Application Serial No. 10/582,700  
Reply to Office Action dated October 28, 2008  
Amendment dated February 24, 2009

**AMENDMENTS TO THE DRAWINGS**

### **REMARKS**

Fig. 1

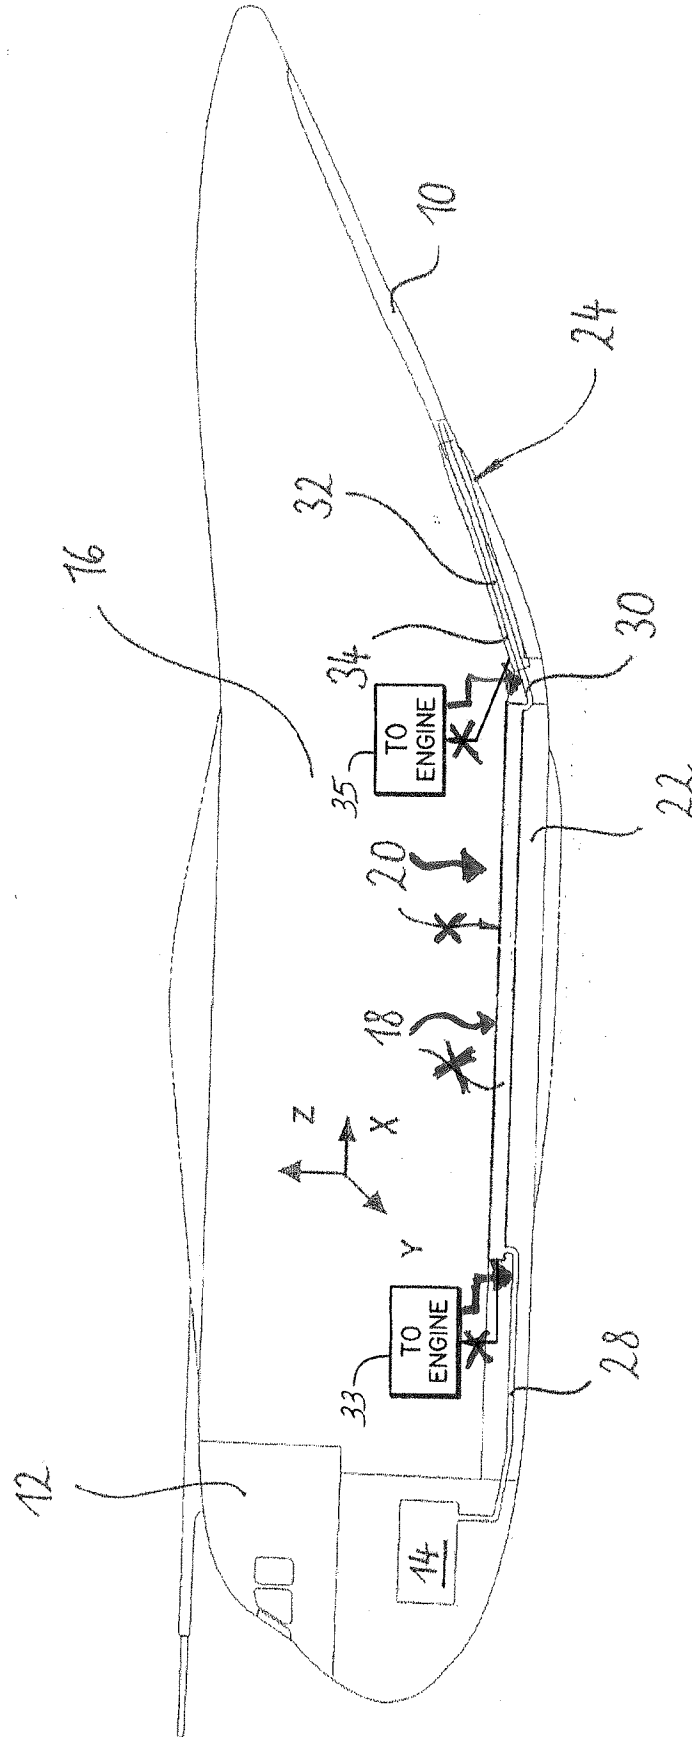
The Office Action objected to the addition of feed lines (33, 35) in FIG. 1 because the arrows drawn extended from the floor and cargo door to the engine. The arrows have now been amended in the replacement drawing sheets to indicate the proper direction of flow of hot engine bleed air. As discussed previously, these features are supported in the original Specification. For at least these reasons, Applicants respectfully request that this objection be withdrawn.

Fig. 2

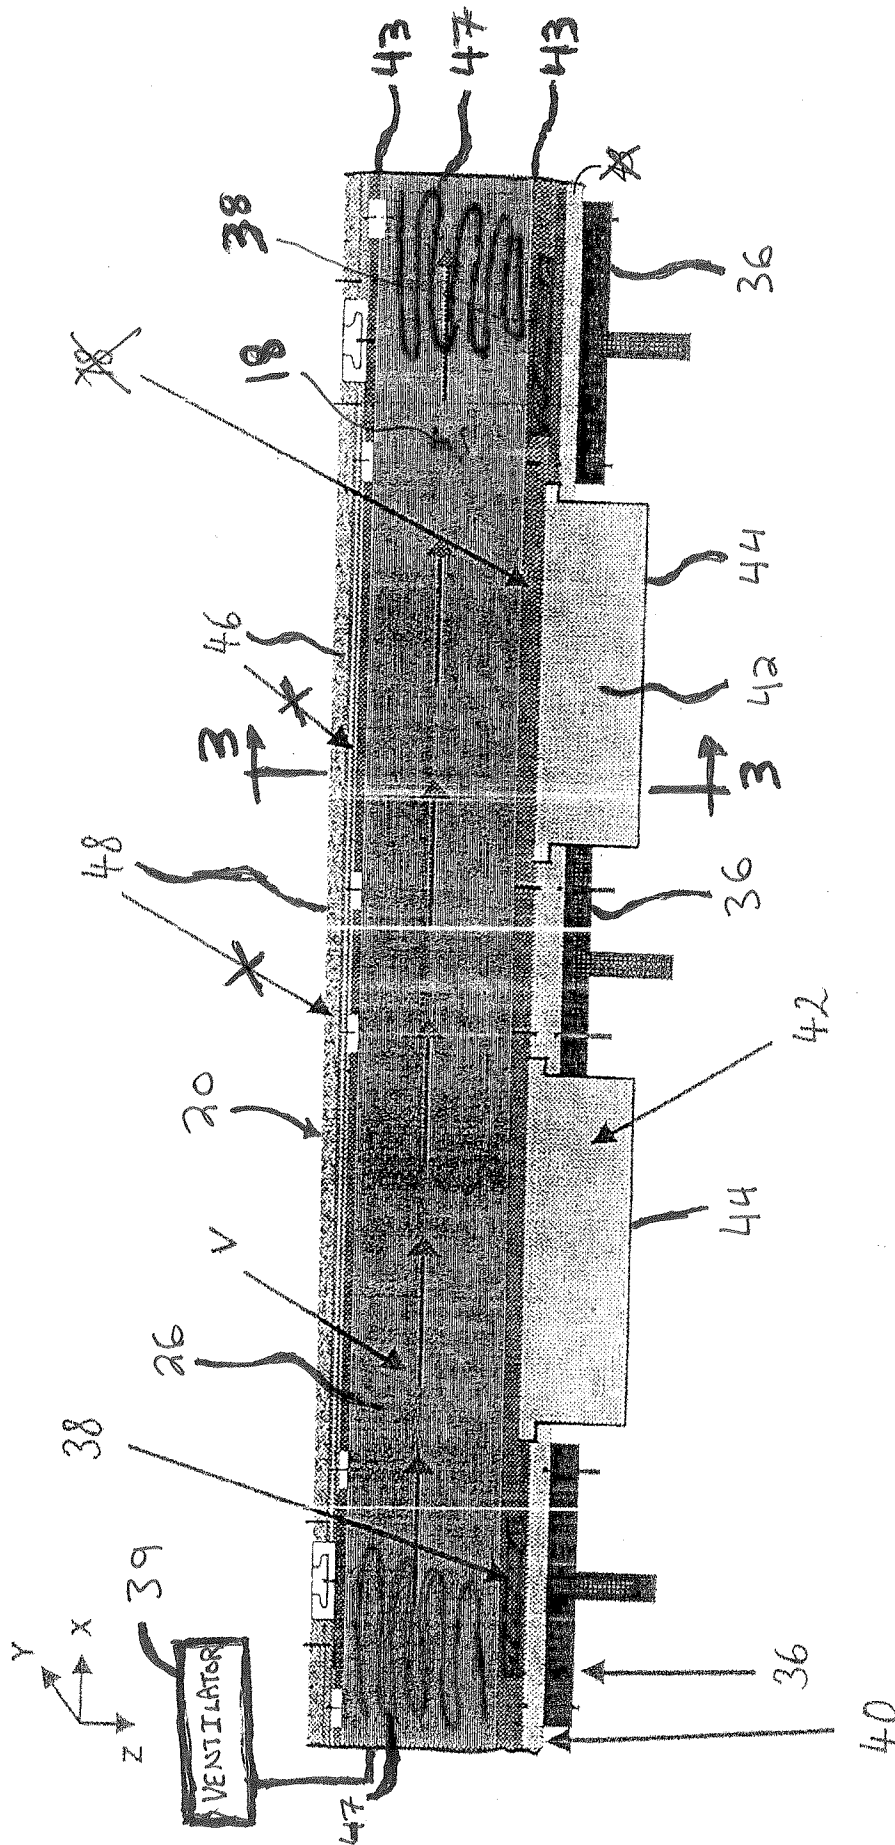
The Office Action further objected to the addition of reference numeral 43 to reference heating mats in FIG. 2. FIG. 2 in the replacement drawing sheets has been amended to clearly distinguish the rigid insulation (40) and the heating mats (43). The

placement of the heating mats was supported in the original Specification at paragraph 0018, which states "[t]his additional electric heating can be provided, for example, by means of conventional electric heating mats which are positioned on the upper side and/or the lower side of the panels which make up the floor." For at least these reasons, Applicants respectfully request that this objection be withdrawn.

Fig. 3

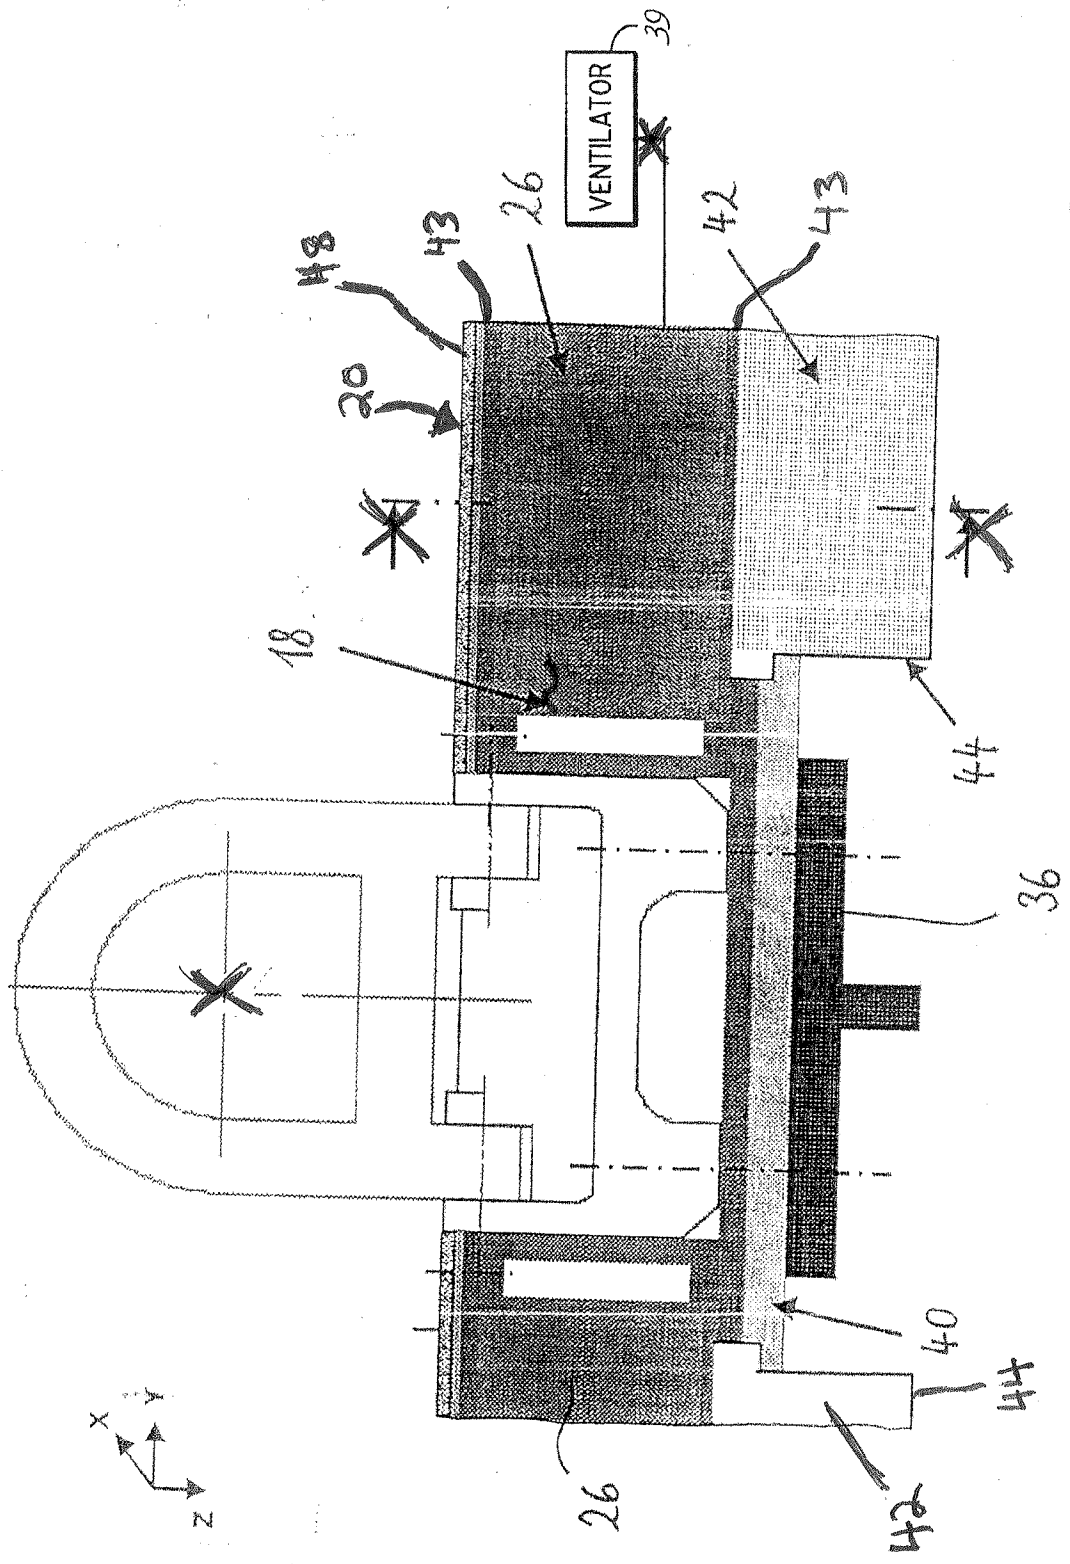
The Office Action also objected to the proposed addition of "[i]f desired, as shown schematically in FIG. 3, a ventilator 39 may be used to generate a forced flow through the first hollow ventilator 26." Applicants respectfully traverse this objection. The added text is supported at paragraph 0011, which states "a forced flow is generated in the panels of the floor or the cargo hold door, for example by means of ventilators or similar." Additionally, this added line in the Specification has been currently amended to correct the name of item 26. For at least these reasons, Applicants respectfully request that this objection be withdrawn.

The Office Action objected to the addition of ventilator (39) in FIG. 3. To dispel any confusion regarding the schematic representation of the ventilator, FIGS. 2 and 3 have been amended in the replacement drawing sheets to remove the arrowheads. Additionally, the ventilator (39) has been positioned behind the direction of flow through the hollow chambers (26) in amended FIG. 2. For at least these reasons, Applicants respectfully request that this objection be withdrawn.
